Product Change Notification

Document No **PCN-A-1060414** Revision **1.0**

PCN TOPIC: Improvement of docking design for vehicle mounted computers.

Comparison Table:

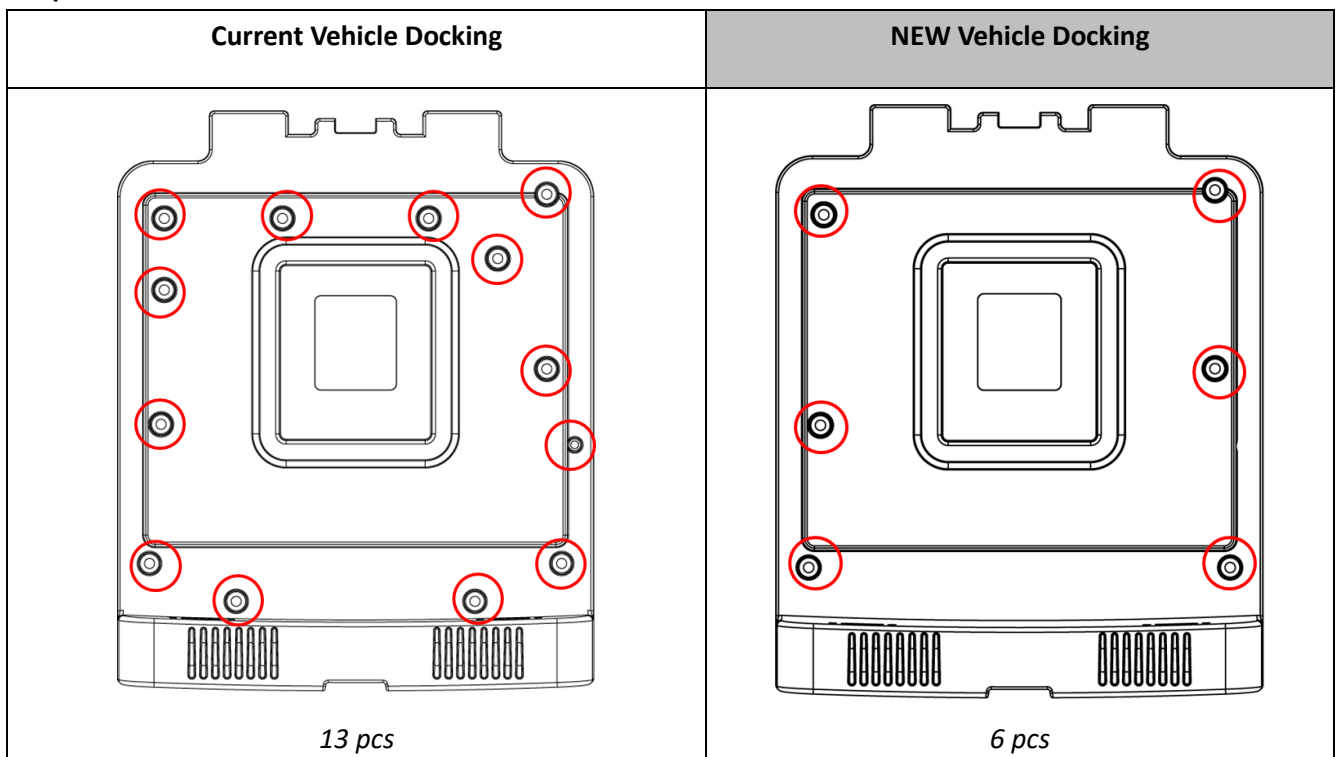
DETAILS: Winmate changes a design of the vehicle docking for FM08, FM10 and FM10A series vehicle mounted computers. The number of screws on the internal side of the docking is reduced from 13 to 6 pieces. This change allows speeding up service and maintenance procedures. Refer to a comparison table below for more details.
